*Comment Received From: Southern California Gas Company
Submitted On: 6/21/2021
Docket Number: 21-BSTD-01*

SoCalGas Comments on the Proposed Changes to the 2022 Energy Code Update Rulemaking

Subject: Comments on the Proposed Changes to the 2022 Energy Code Update Rulemaking

Figure 1: Capacity Value Forecast

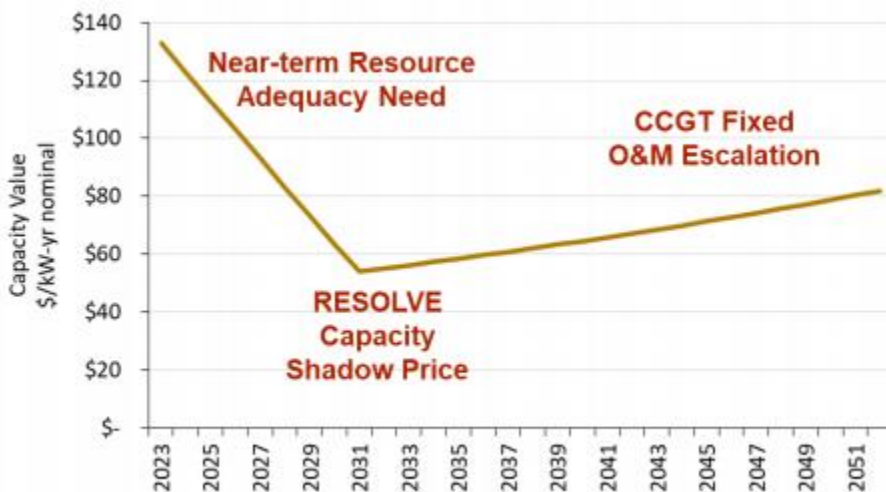
Likewise, we note that the gas supply costs associated with the operation of the combined cycle gas turbine (CCGT) resources are likely understated. According to the CEC analysis, the cost of the CCGT assets is constant in real terms after 2031 as indicated in Figure 1.⁸

However, this assumption is at odds with the need to maintain the means by which CCGTs obtain fuel (the gas transportation and distribution networks) over the same period during which throughput and distribution customer count are projected to decrease. In practical effect, CCGTs will be bearing more of the gas system costs (including for firm transportation service) with fewer units of electricity production, which will result in a corresponding increase in the costs for electricity and output. Because gas throughput will decline and infrastructure costs will not decline commensurately, the electricity prices from CCGT will not remain constant after 2031 but will likely increase. Please see Appendix C for additional detail.

Figure 2. Scenario with Equal Maintenance Cost for Gas Instantaneous and HPWH

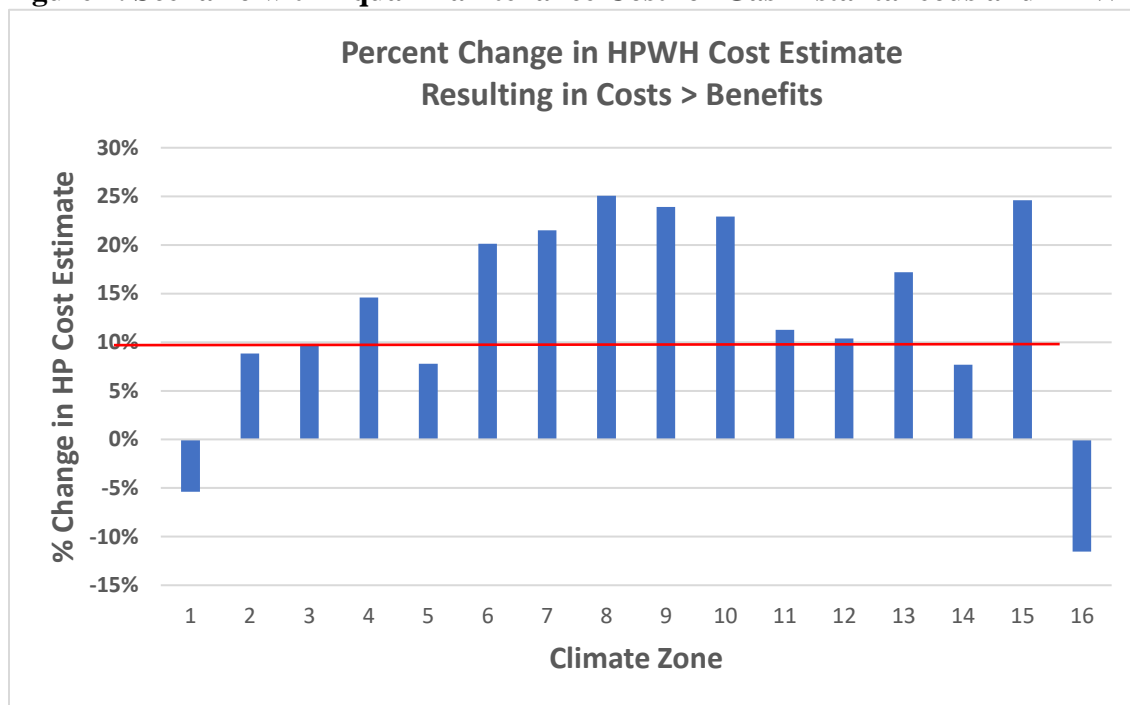
Additionally, SoCalGas ran some sensitivity analysis to check the variations in incremental cost (on top of the maintenance cost addition) that would impact the cost-effectiveness of these technologies. The results are shown in 2, which shows the percent change in HPWH cost that would result in the total cost exceeding the total long-term benefits offered by this technology, in each climate zone. As is clear from the Figure 2, a 10 percent increase (indicated by a red horizontal line) in the cost of a HPWH could potentially result in overall higher costs than benefits in several of the climate zones. Climate zones 1 and 16 show they are already not cost effective using the same maintenance costs, but with an increase of 10 percent maintenance costs climate zones 2, 3, 5, and 14 are also no longer cost-effective. Uncertainty in other variables, including the TDV values for natural gas and electricity could result in changes in the economic balance in additional climate zones. We also want to point out that incremental costs can vary widely based on factors such as location, contractor, installation scenario as well as customer behavior, which has a significant impact on the actual incurred maintenance cost and can vary from customer to customer.

Figure 3. Natural Gas Price Projections Over Time as a Factor in Commodity Costs

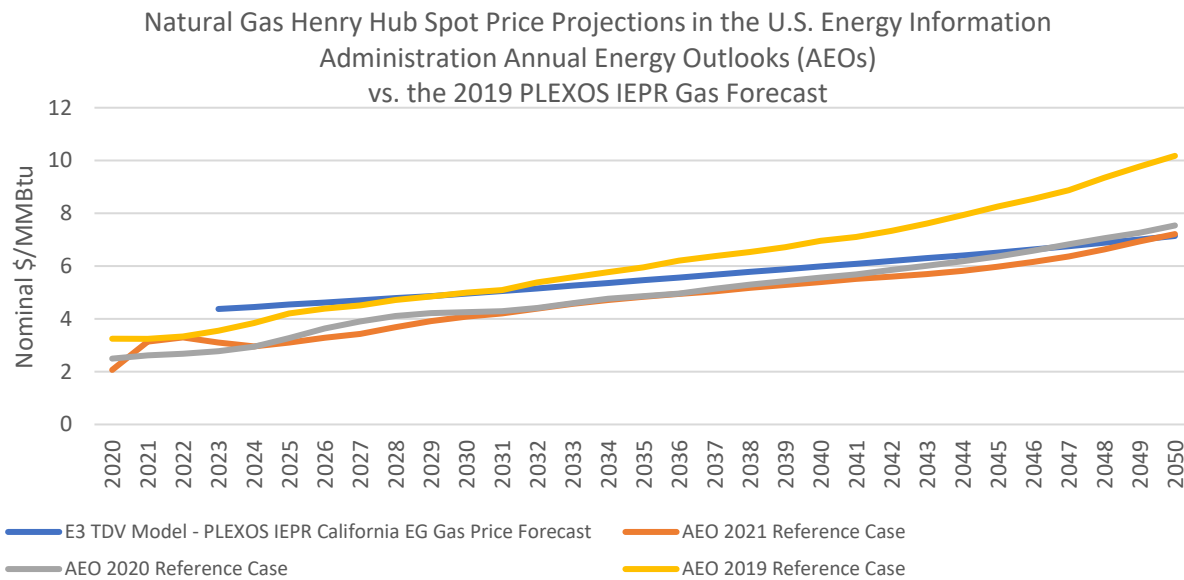
SoCalGas believes that the natural gas commodity prices were overestimated due to the use of an outdated natural gas price forecast. For instance, the CEC consultants Energy + Environmental Economics (E3) used the PLEXOS Integrated Energy Policy Report (IEPR) California EG Natural Gas Price Forecast (Nominal \$/MMBtu) for 2019. As SoCalGas does not have access to the PLEXOS Forecast for 2019, we compared the U.S. Energy Information Administration (EIA) Annual Energy Outlook (AEO) values for 2019, 2020, and 2021 to estimate the decline in gas price outlook between 2019 and 2021.^{23,24} As shown in Figure 3, we found that, on average, the 2019 AEO overestimated natural gas spot price projections (in nominal dollars/MMBtu) at Henry Hub by 20 percent compared to the 2020 AEO, and by 21 percent compared to the updated 2021 AEO. Meanwhile, the 2019 PLEXOS forecast was 11 percent higher on average than the 2020 AEO forecast and 14 percent higher on average than the 2021 AEO forecast. Older gas price projections tend to overestimate prices relative to more recent studies. The commodity price of natural gas is just one of five inputs, but an overestimate of about 20 percent in the commodity price, coupled with a huge increase in the retail adjustment and an unverified “emissions abatement” cost can result in price factors that are unreliable and excessively inflated.

The projection of natural gas prices for the Proposed 2022 California Energy Code update reflects a dramatic increase, about 33 percent, in the consumer gas prices relative to the 2019 forecast. More than half of this increase is due to an increase in the retail rate adjustment. The retail rate adjustment by itself represents the single largest component of the potential gas cost accounting for more than 40 percent of the total gas costs. The retail rate adjustment is based on a utility cost allocation reflecting a significant

Figure 4. 2019 vs 2022 Natural Gas TDV

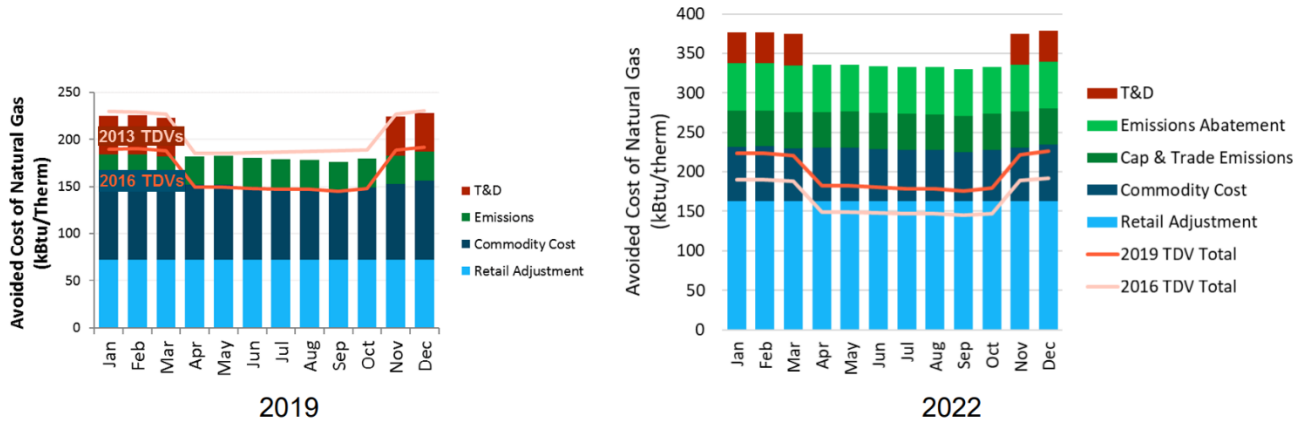
A more accurate representation of retail rates using the estimated relationship between declining volumes and declining costs would have resulted in substantially lower consumer gas prices. In addition, the use of the Retail Rate Adjustment to capture unrecovered revenue by increasing rates, and then including the impact of the higher rates as a cost in the TDV analysis is inconsistent with economic theory and with economic equity. This component of the Retail Rate Adjustment is simply a transfer cost; a shifting of costs from customers that leave the gas system onto the customers that remain on the gas system. Hence, the customers that are unable or unwilling to pay the costs of converting from natural gas to electricity pay the system costs for the customers that can leave the gas system. And this increase in costs to the customers that can’t leave the gas system is used to justify the building code changes that encourage other customers to move off the gas system. Despite the inclusion of the retail rate adjustment in the marginal natural gas costs, there are no true societal cost savings associated with this element of the TDVs. Figure 4 shows the magnitude of overestimation in the CEC’s assumptions with the Retail Rate Adjustment; it

goes from about \$70 of avoided cost of natural gas (kBtu/Therm) in the 2019 forecast to \$160 of avoided cost of natural gas (kBtu/Therm), which is an increase of about 225 percent.

Figure 5. E3's Comparison of the Hydrogen Price Estimates in the MHPS Study (June 2020) and in the CEC Retail Gas Study (April 2020)³⁵

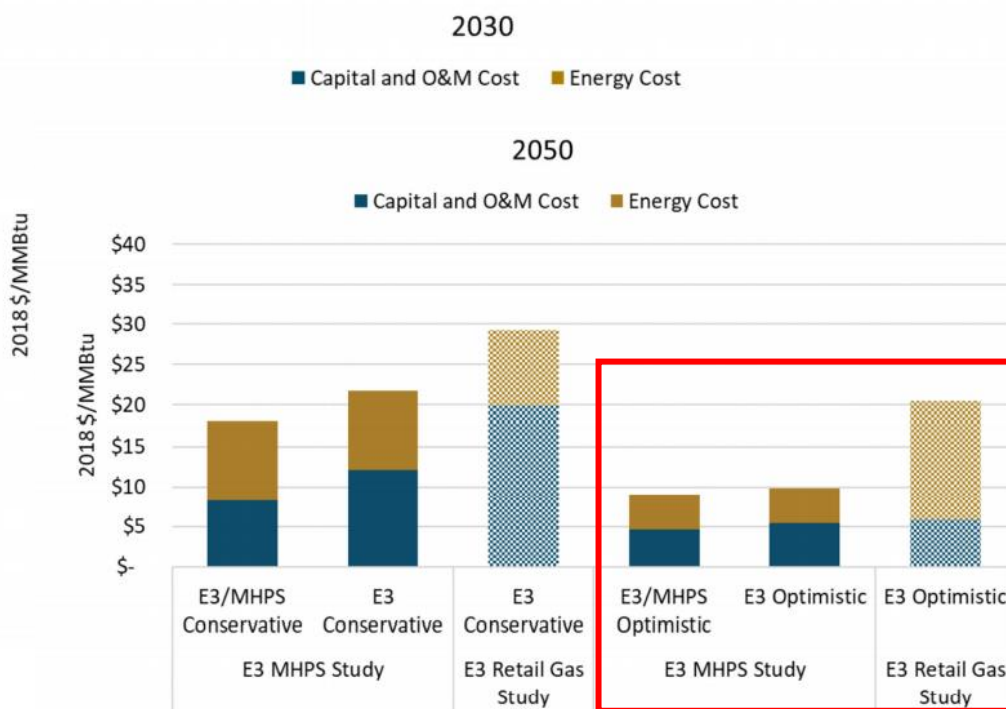
While the contemporaneous E3 study³² did not reflect the CEC views and is based on a different set of assumptions developed for a different client with a different perspective on the market, SoCalGas believes that at a minimum, the CEC analysis should recognize variations among hydrogen price forecasts and that used in the TDV (suggesting that it reflects a somewhat conservative projection of future costs). As such, assessment and consideration of additional scenarios more in line with current industry expectations would enhance the efficacy and accuracy of the analysis. For instance, during the same time period, other public reports³³ projected that delivered hydrogen costs would fall to \$15/MMBtu by 2030 and to \$7.4/MMBtu by 2050, if a significant public investment in hydrogen technology is made. Furthermore, the U.S. Department of Energy (DOE) recently announced a “Hydrogen Energy Earthshot” program that presents a hydrogen production cost target of about \$7.4/MMBtu by 2030.³⁴

Figure 6: Indoor PM_{2.5} and NO₂

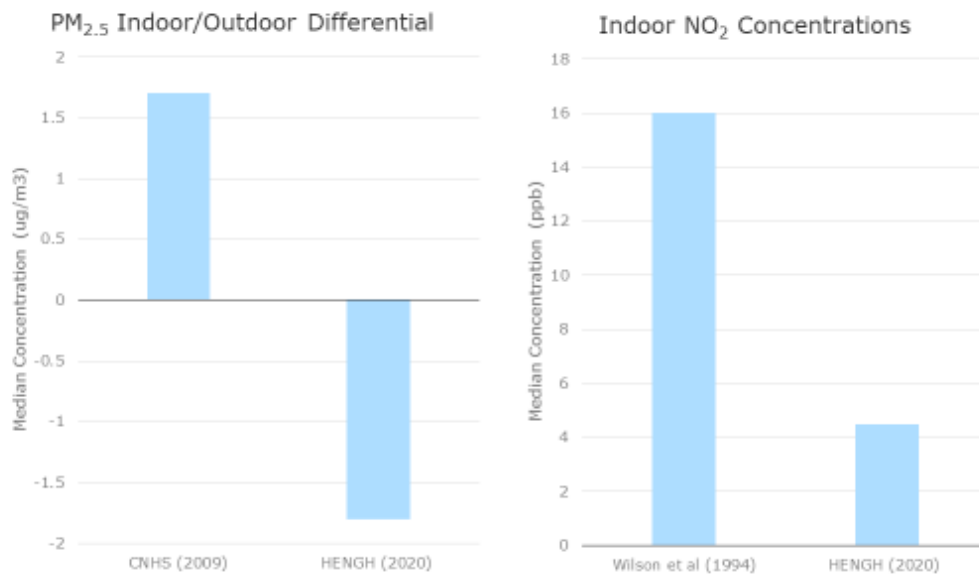
Finally, as illustrated below in Figure 6,^{50,51,52} indoor PM_{2.5} and NO₂ concentrations have been decreasing. Thus, residential exposures to air pollutants from gas appliances are decreasing and are much lower now than 20 years ago. PM_{2.5} emission reduction drivers are lower outdoor PM_{2.5} emissions, high efficiency air filters in central forced air systems and mechanical ventilation systems. NO₂ emission reduction drivers are mechanical ventilation and lower outdoor NO₂ emissions.
